Oyster Creek Generating Station
US Route 9 South
P.O. Box 388
Forked River, NJ 08731

August 27, 2004
2130-02-20203

Oyster Creek Generating Station
Facility Operating License No. DPR-16
NRC Docket No. 50-219

**Subject: Technical Specification Change Request No. 331 –
Safety Limit Minimum Critical Power Ratio**

Figure 1
Reference Loading Pattern – Oyster Creek Cycle 19

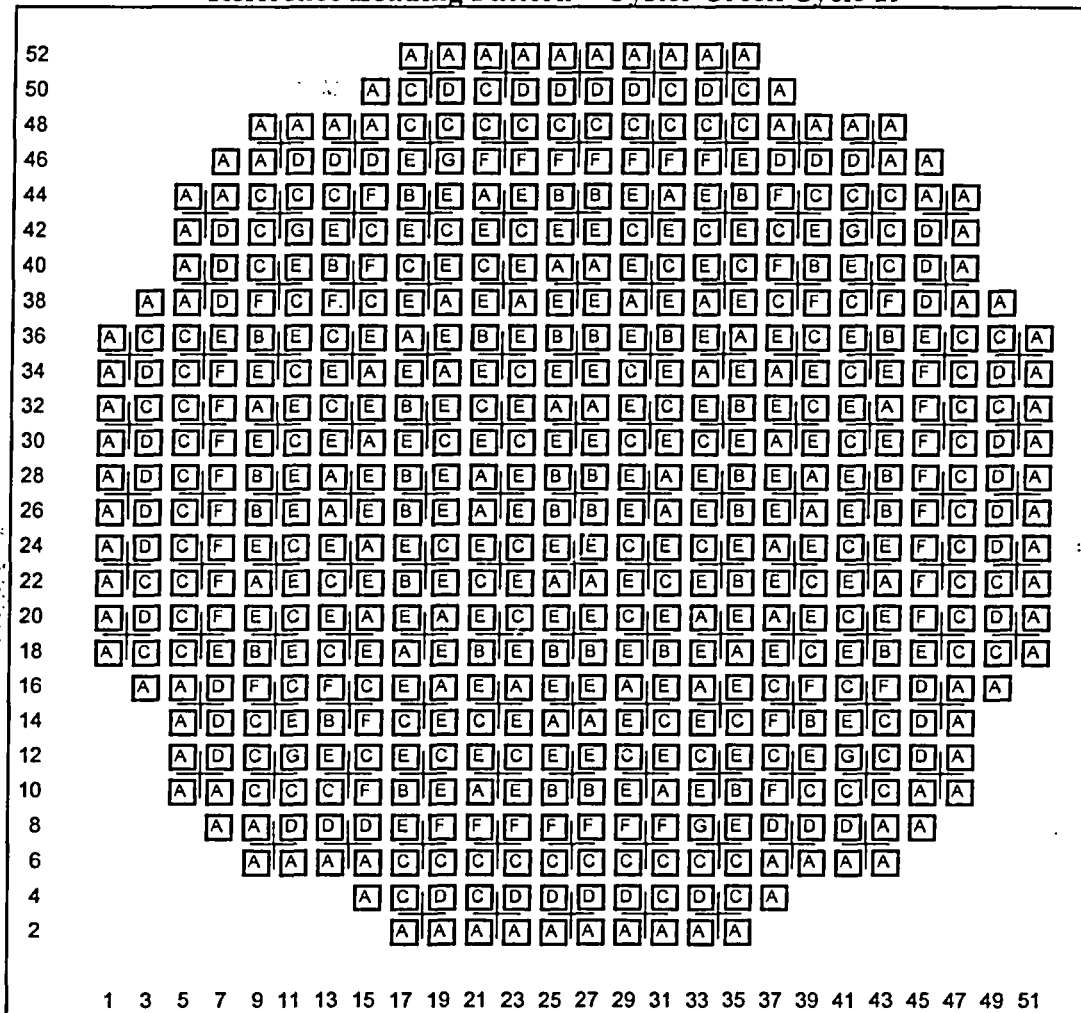
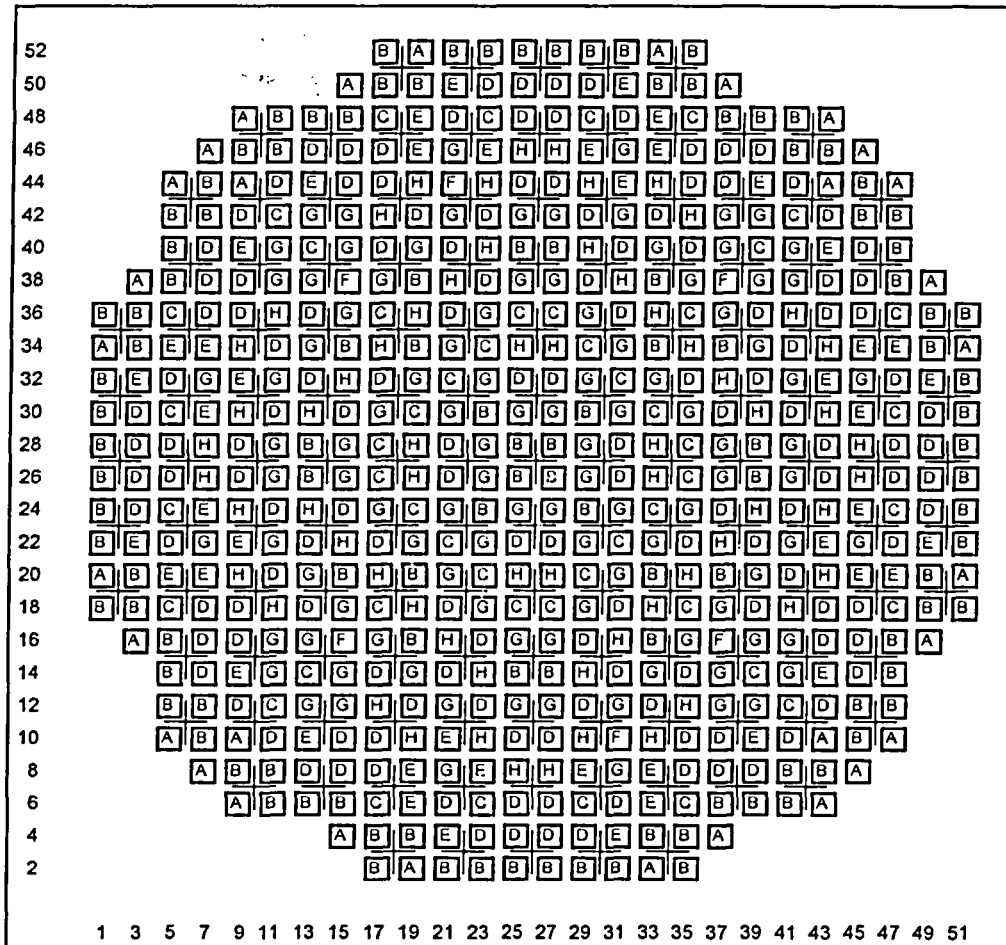
In general, the calculated safety limit is dominated by two key parameters: (1) flatness of the core bundle-by-bundle MCPR distributions, and (2) flatness of the bundle pin-by-pin power/R-factor distributions. Greater flatness in either parameter yields more rods susceptible to boiling transition and thus a higher calculated SLMCPR. The impact of these parameters on the Oyster Creek Cycle 20 and Cycle 19 SLMCPR values is summarized in Table 1.

The core loading information for Oyster Creek Cycle 19 is provided in Figure 1. For comparison the core loading information for Oyster Creek Cycle 20 is provided in Figure 2. The impact of the fuel loading pattern differences on the calculated SLMCPR is correlated to the values of [[

As shown in Table 1, the SLMCPR for both four and five loop operation (FLO) is 1.10. For three loop operations (3LO) the calculated safety limit MCPR for the limiting case is 1.12 as determined by specific calculations for Oyster Creek Cycle 20.
